MANSOURAH - MASSARAH GOLD PROJECT
DETAIL DRAWING
STORMWATER TYPICAL DETAILS-ACCESS ROAD TO MANSOURAH-MASSARAH PROCESS PLANT
SHEET 2 OF 3

DRAWING NUMBER MD - 216 - 49EA - EG - CV - DED - 1004
REV D01

Mansourah Massarah Gold Project
Comment Resolution Log Sheet / Compliance Report

PROJECT: MANSOURAH MASSARAH GOLD PROJECT **PROJECT NO.: 216**

PLAN FOR IRISH CROSSING
TYPE 'A'

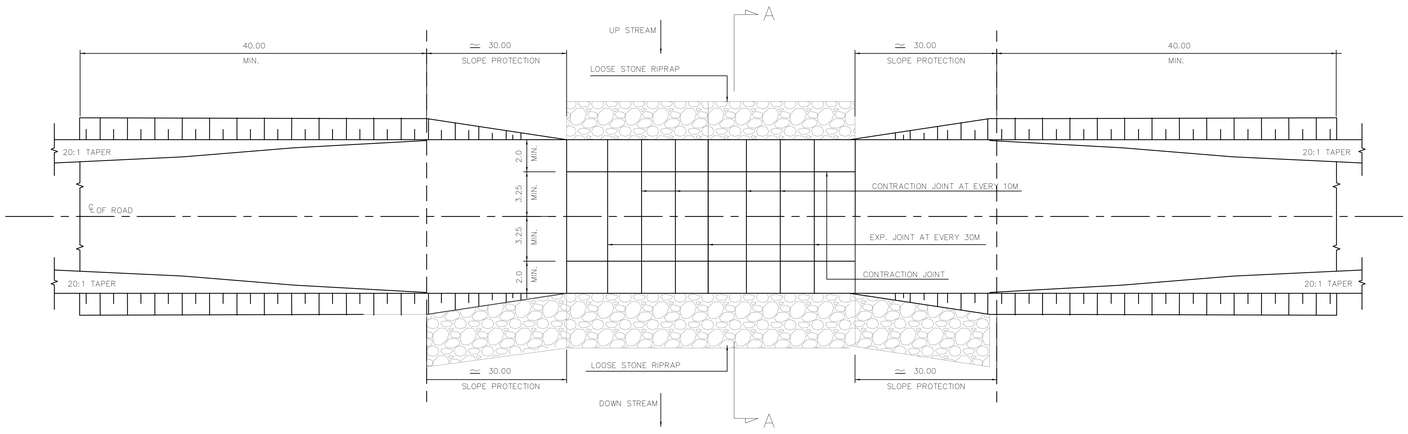
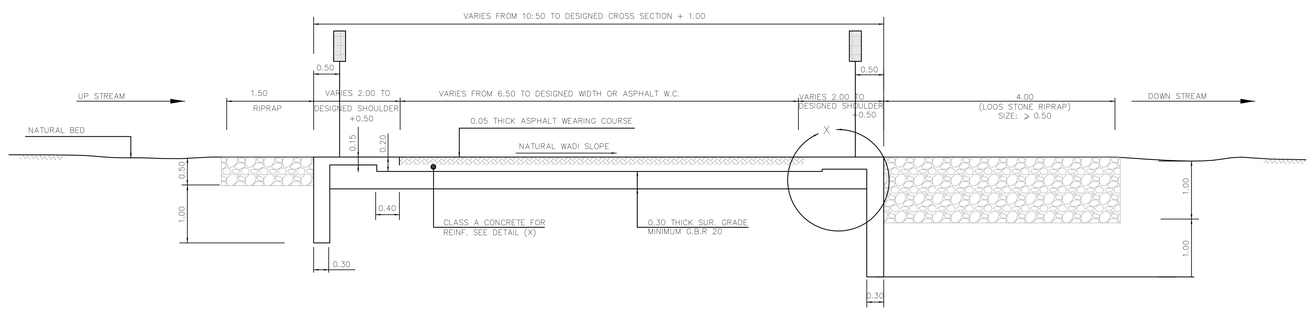
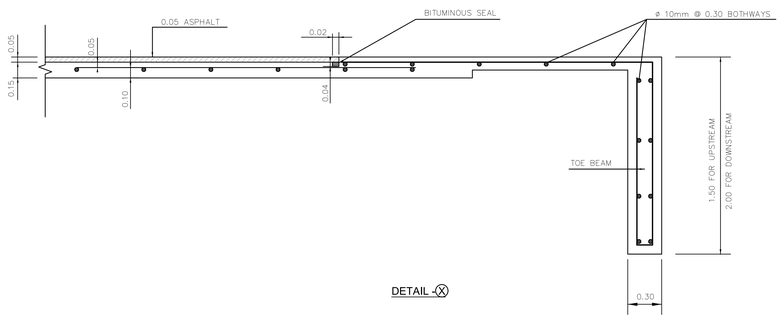
DOCUMENT NUMBER	Area / Title	Comment No.	PMC/PMT COMMENT DATE: 09 February 2022	Comment by	EPC Response DATE: 03 February 2024	Status	Remarks
			General Comments (cc)				
MD-216-49EA-EG-CV-DED-1004-A04	49EA	1	- No hydraulic analyses have been included for supporting the design of Irish crossings. Hydraulic analyses are still required, using an appropriate software such as HEC-RAS, Flow-2D, or similar. For instance, it is said that the flow velocities are minimal at the crossing points, but this must be demonstrated with the results given by an appropriate hydraulic model. Standard designs offered by the MOT are limited to certain hydraulic parameters, therefore the EPC must confirm (through hydraulic modeling) that the specific hydraulic conditions of each crossing are adequate.	Bechtel	Incorporated in the revised drawing.	Closed	
MD-216-49EA-EG-CV-DED-1004-A04	49EA	2	Section 5 of the report cited provides the rationale for computing the design flows using the software HEC-HMS, which is fine. Section 6 “Hydraulic Design” does not provide sufficient background and supporting information for reaching the design conclusions given in Table 12 for Irish crossings. There is one appendix showing hydraulic analyses for culvert crossings only. Hydraulic analyses for Irish crossings are still required.	Bechtel	Incorporated in the revised drawing.	Closed
